# City of Oregon City

## Meeting Agenda Planning Commission

**4a. Planning File NR 17-0010: Natural Resource Overlay District Review application for a Deck Expansion at 379 Barker Avenue**

File Number: PUB 17-022

Figure 9: Proposed Mitigation Plan

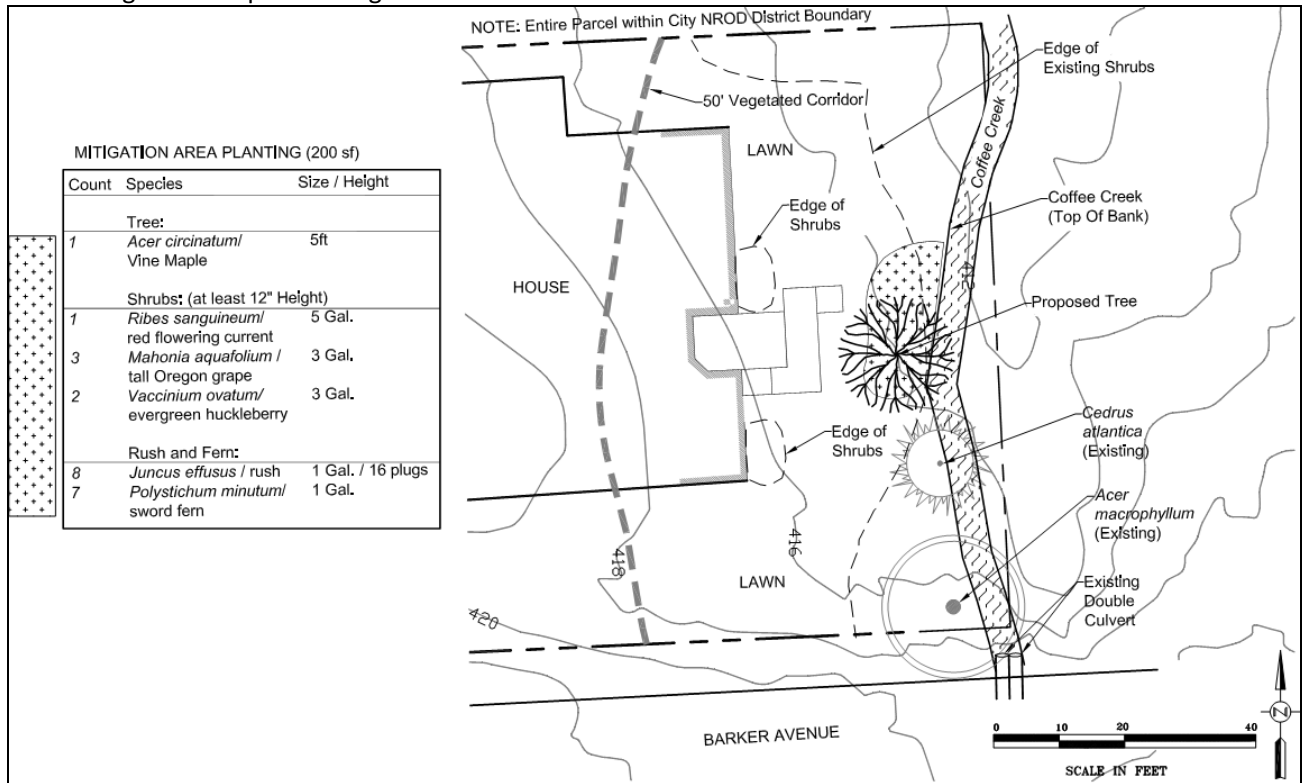
1. The applicant shall submit a revised mitigation plan:
  - a. Identifying that the bare ground in the mitigation area will be planted or seeded with native grasses or herbs. (P)
  - b. That demonstrates compliance with plant spacing standards in accordance with OCMC Section 17.49.180.E.2.c. (P)

FIGURE  
3A

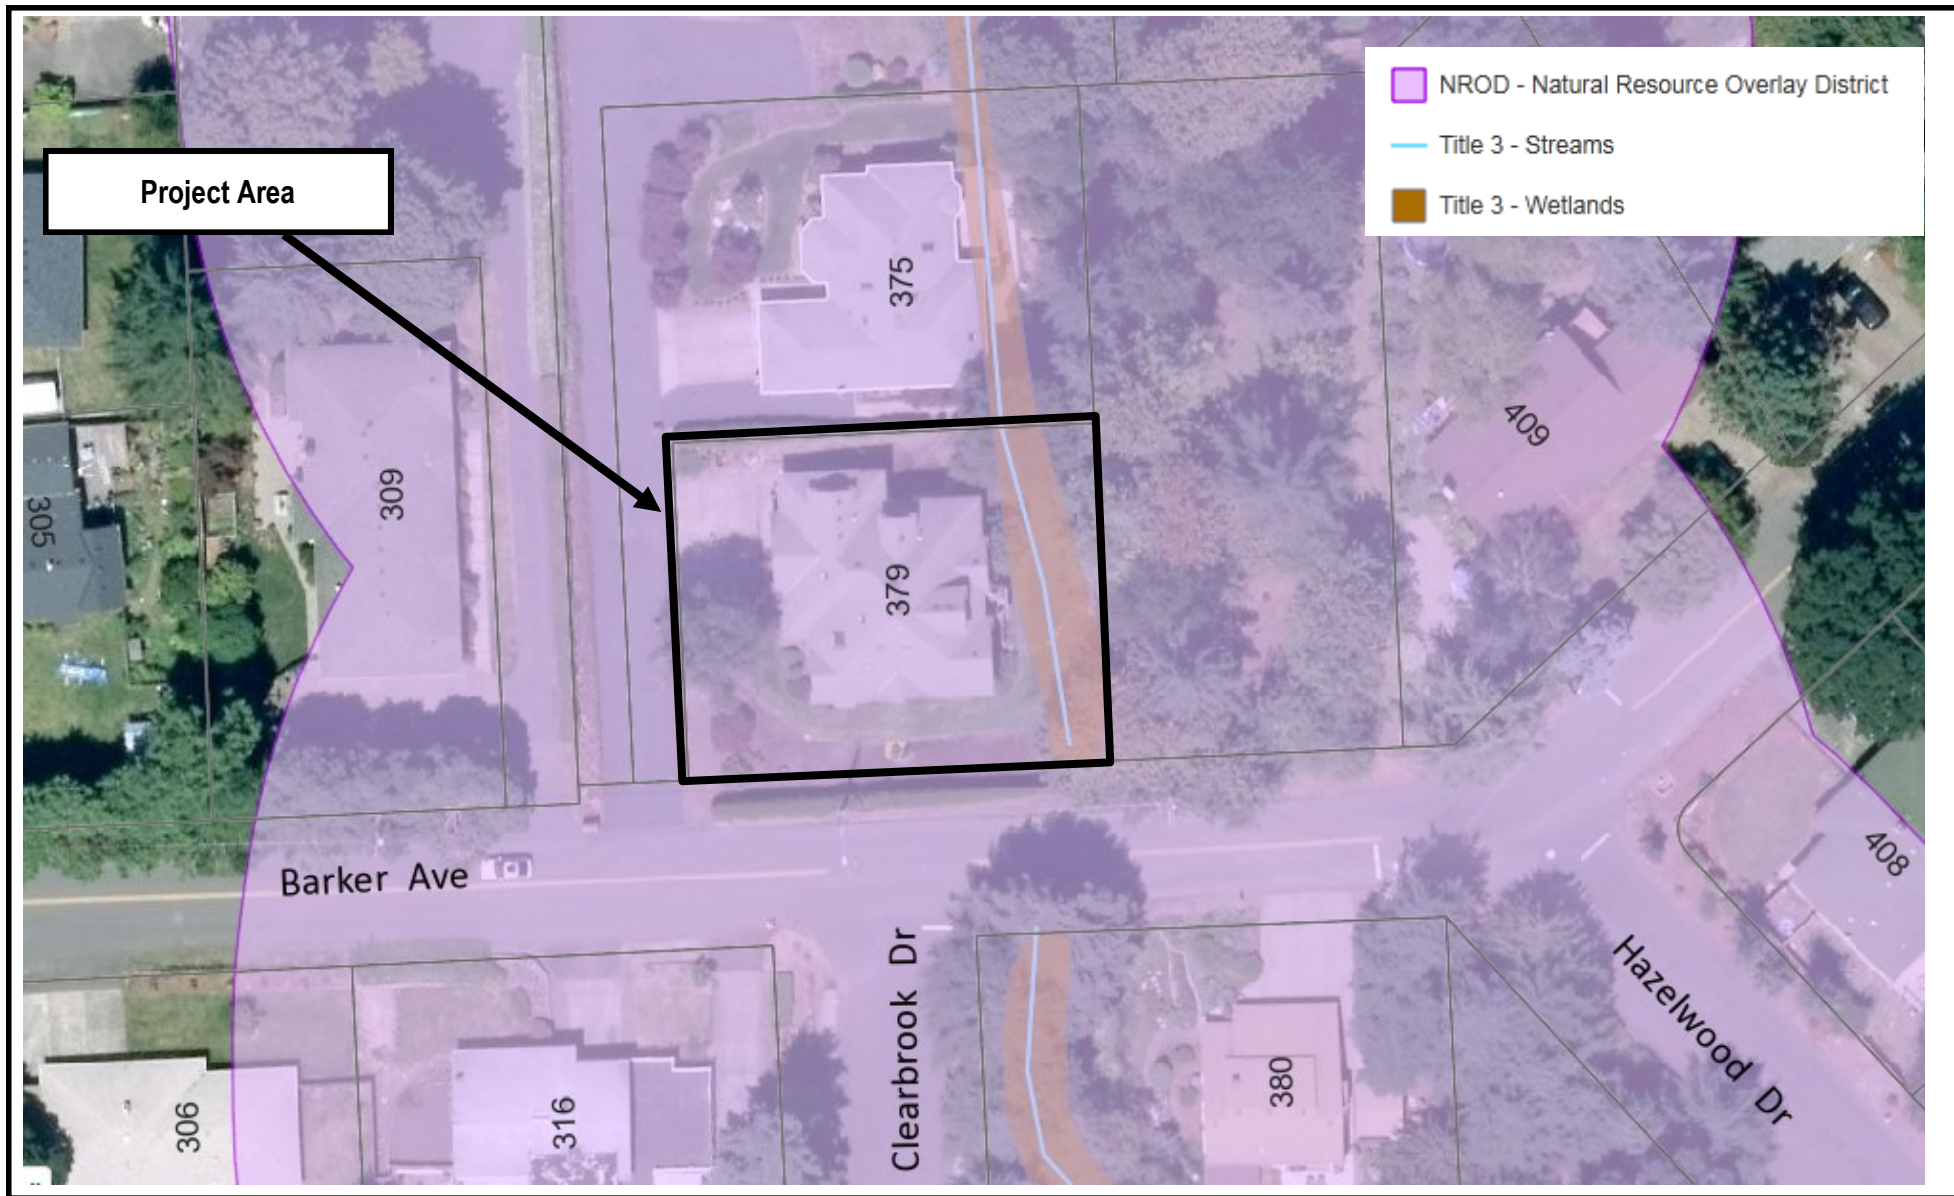
- ✓ **17.49.060.B. Compliance with Federal and State Requirements.** The NROD report and the applicant's submittal state that there are no wetlands on the site, and PHS collected one sample point and included the wetland determination data form as well as the City inventory on Figure 3A. The wetland manuals cited are current.

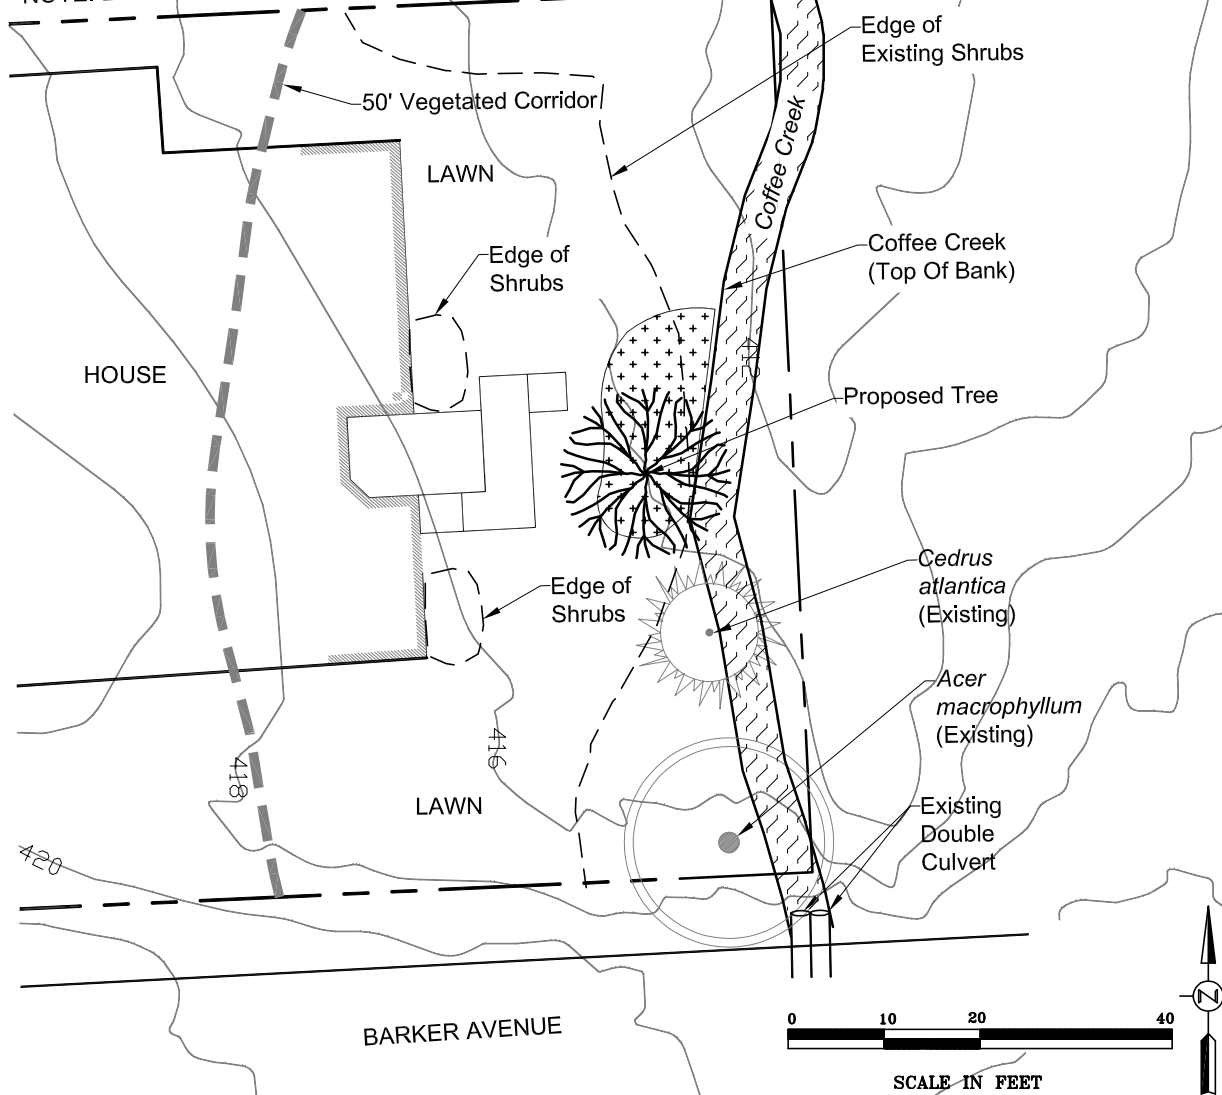
- ✓ **17.49.180 Mitigation Standards** DEA verified the PHS calculations: the requirements are for 200 square feet of mitigation area, 1 tree, and 5 shrubs, and the planting plan on Figure 6 ("Mitigation Plan") appears to conform to spacing and size requirements. The tree, shrubs, and rush/fern listed on the plan are on the Oregon City Native Plant List.
